RE: Change Order No. 1 and 2- Safe Roads to School- Our Lady of Hungary- Project No. 122-007

TO: Board of Public Works
FROM: Gemma Stanton, Project Engineer
SUBJECT: Change Order #1 and #2
SRTS Our Lady of Hungary
DATE: 10/6/2025

Description: Non-Participating Sidewalk and Curb Ramps

RE: R-44114 South Bend Safe Routes
Pre-Final Inspection Meeting Minutes

808 W Calvert St -- west side along Chapin – 134ft x 5ft sidewalk added

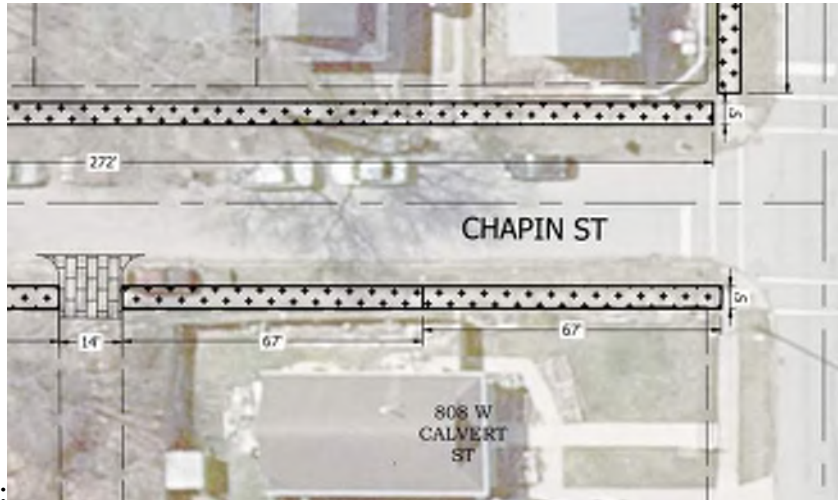
Field measured 322.2ft x 5ft total for 179 SYS of removal and replacement
Removal = 179SYS x \$29.55 = \$5,289.45
Replacement = 179 SYS x \$65.69 = \$11,758.51

730 W Calvert, 726 W Calvert – 92ft x 5ft added on Calvert AND 98ft x 5ft added on Kendall

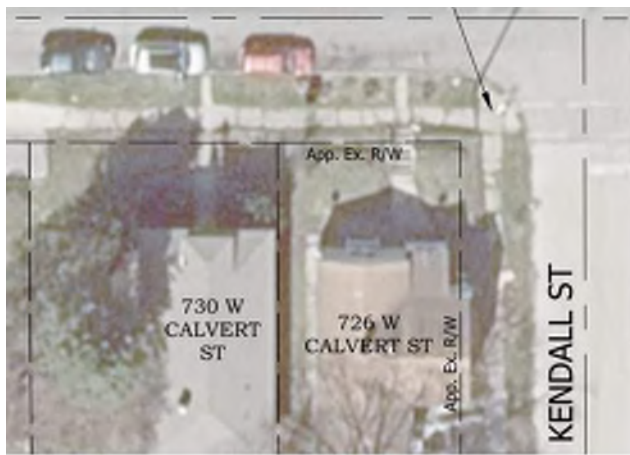
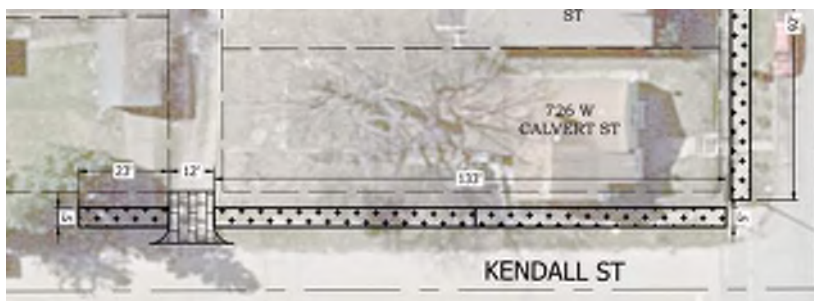
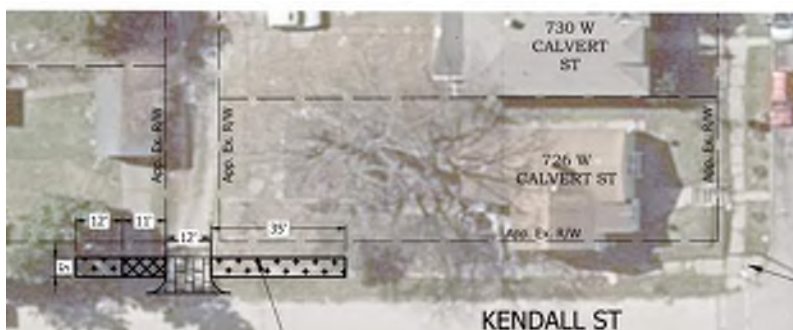
I had a meeting our environmental team to review the NEPA document. Since the project map and write ups are very detailed on the locations (Example NEPA PDF Page 16-19, 77-79, 85-88), they stated that we would not be able to add work outside of the shown locations. I compared the NEPA plans to the Contract plans for the addresses you provided. See below. We can still add 180 SYS of sidewalk for an estimated cost of \$18,000.
